**TOWN OF NEWBURGH
PLANNING BOARD
TECHNICAL REVIEW COMMENTS**

PROJECT NAME: GOLDEN VISTA AMENDED SITE PLAN
PROJECT NO.: 99-33
PROJECT LOCATION: SECTION 60, BLOCK 1, LOT 9.1
REVIEW DATE: 26 MARCH 2015
MEETING DATE: 2 APRIL 2015
REPRESENTATIVE: JOHN MEYER CONSULTING

AMENDED SITE PLANS GOLDEN VISTA TAX MAP SECTION 60 | BLOCK 1 | LOT 9.1 MEADOW HILL ROAD TOWN OF NEWBURGH, NEW YORK

SP-4

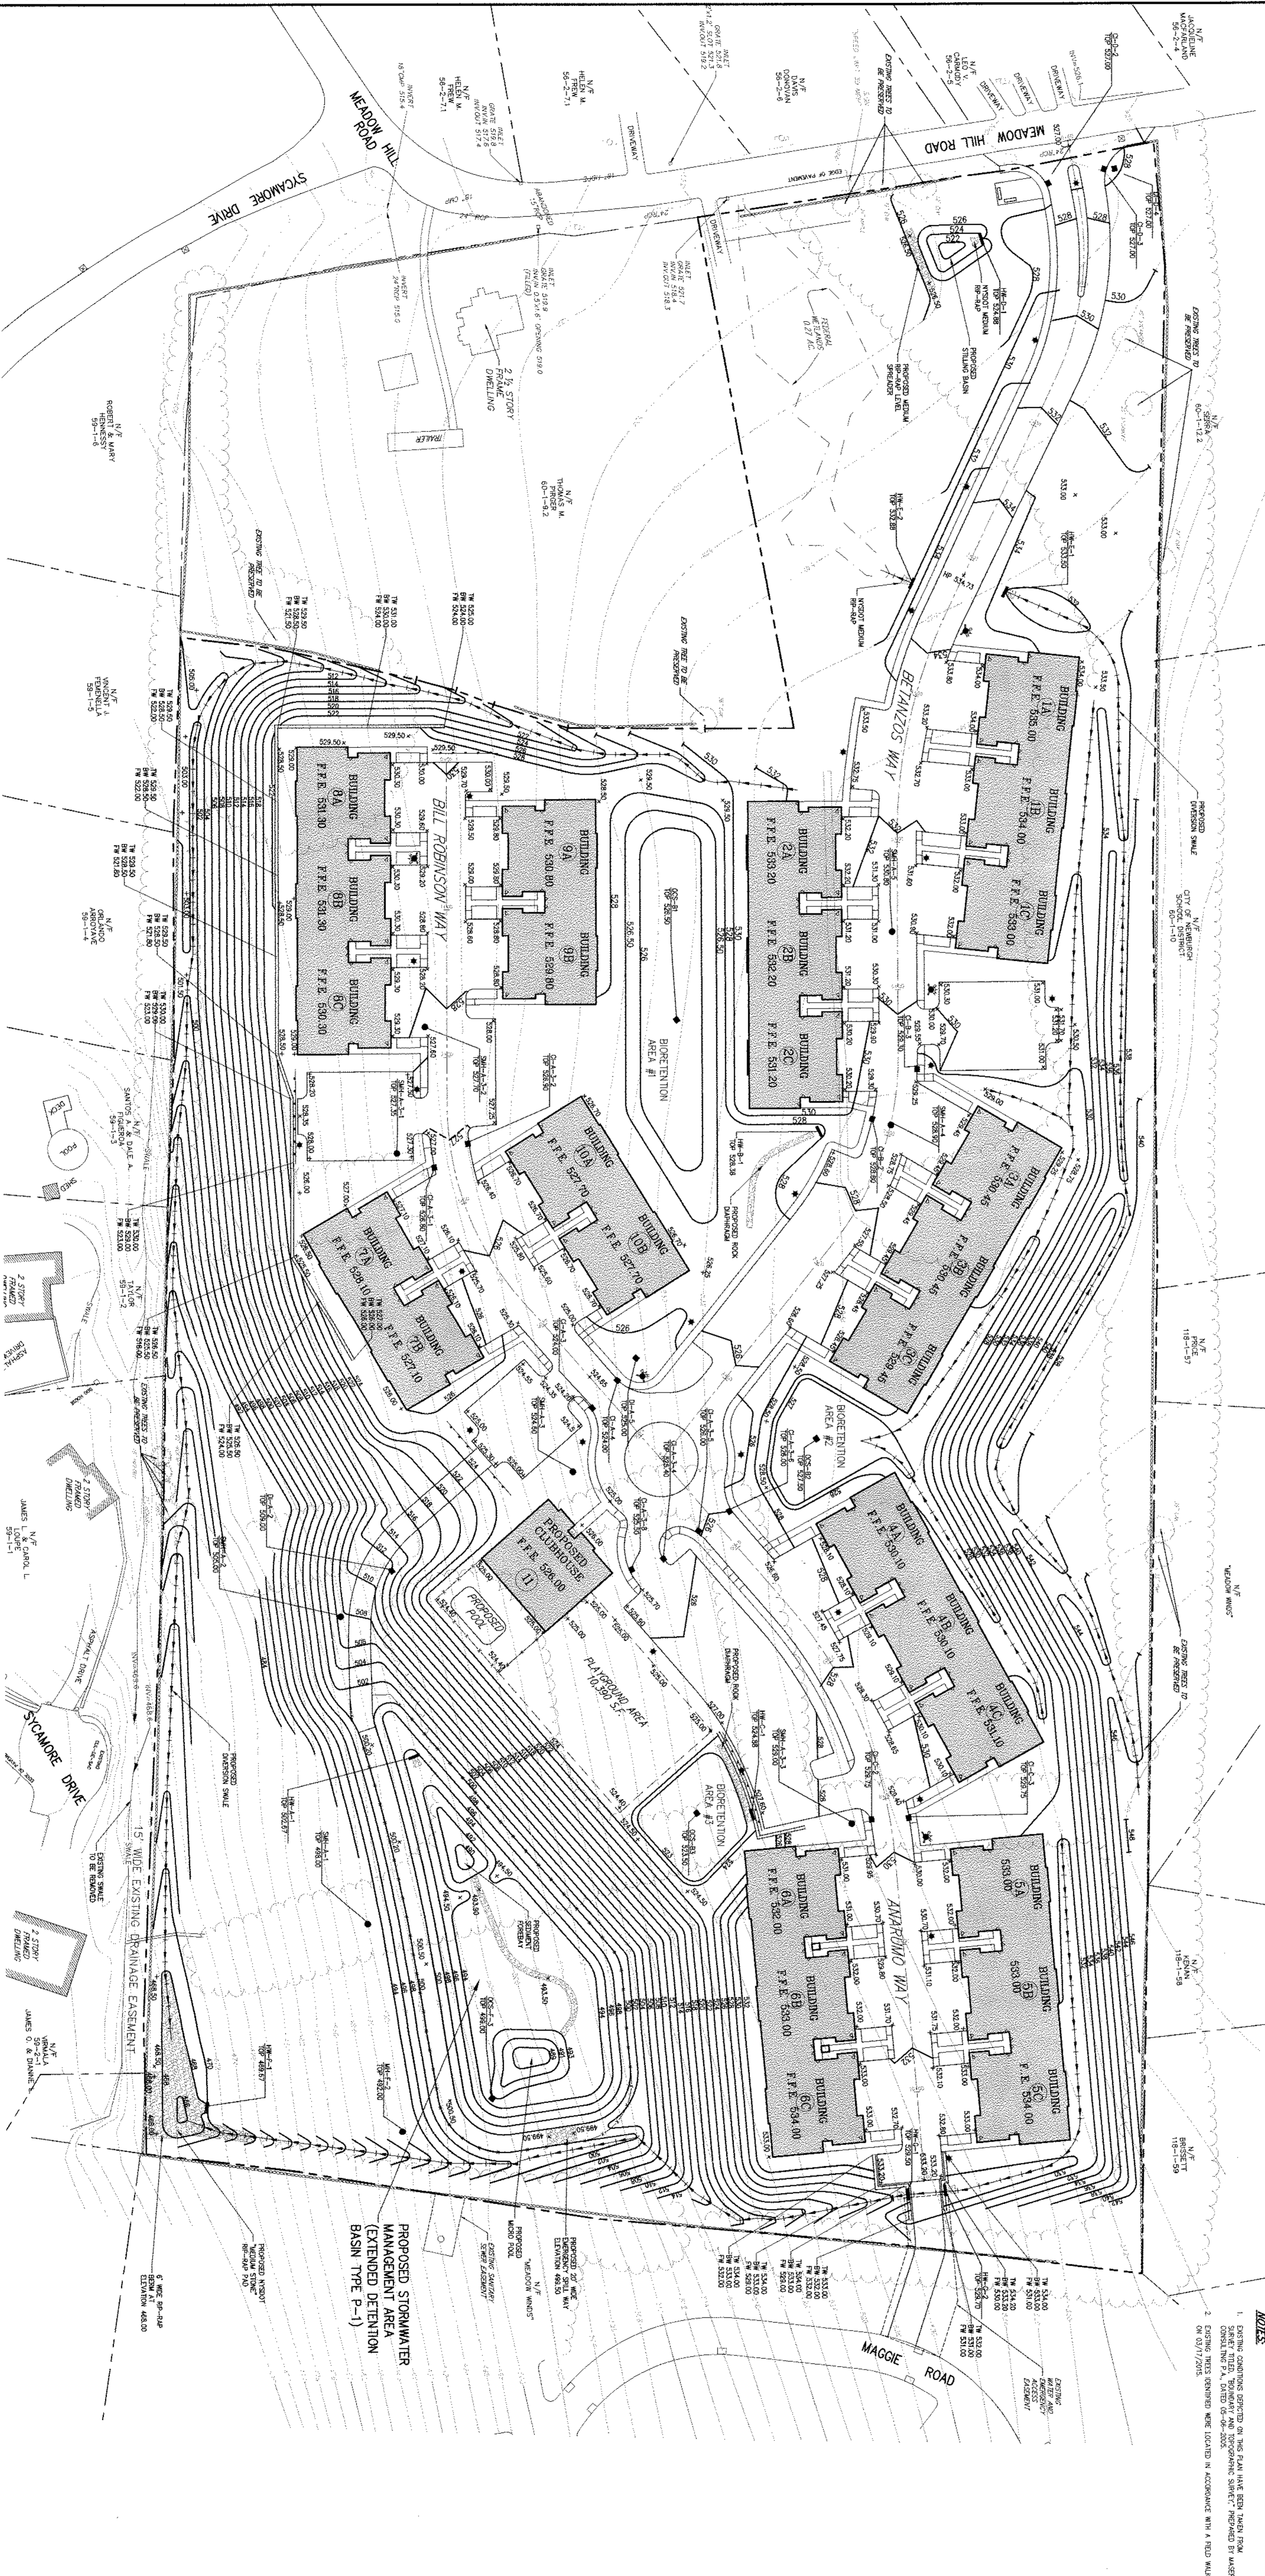
3. Sheet SP4 depicts an existing swale to be removed at the northwest of Sycamore Drive cul de sac. This appears to be outside the property of the project. Unclear why swale would be removed.

4. Drainage along the northern property line from the emergency access road to the extended detention pond discharges via steep slopes. The Applicant's Representative are requested to evaluate slopes in this area as to whether long term stability can be maintained based on storm water velocity on the slopes.

5. One foot of free board should be provided and revised detention pond. Detention pond access road contains spot elevation of 500.20 which would create a low spot in the top of berm.

6. The Applicant's are requested to discuss whether specialized construction techniques will be required for construction of the buildings on fill. Building number 8 as an example has approximately 24 feet of fill under the rear of the structure.

SP-6

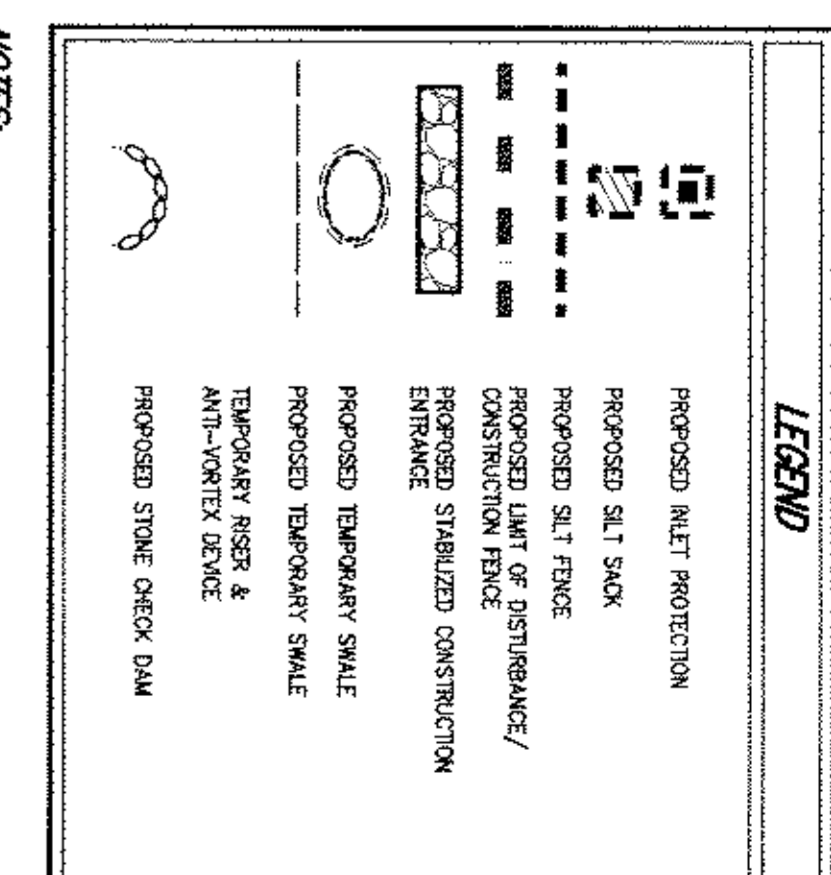
7. Sanitary sewer appears to extend outside of existing sanitary sewer easement on adjoining Meadow Winds project.
8. The soil erosion sediment control plan identifies soil stockpile areas in locations which are proposed to be cut or filled. Interim locations must be provided for stock piles during initial construction phases.
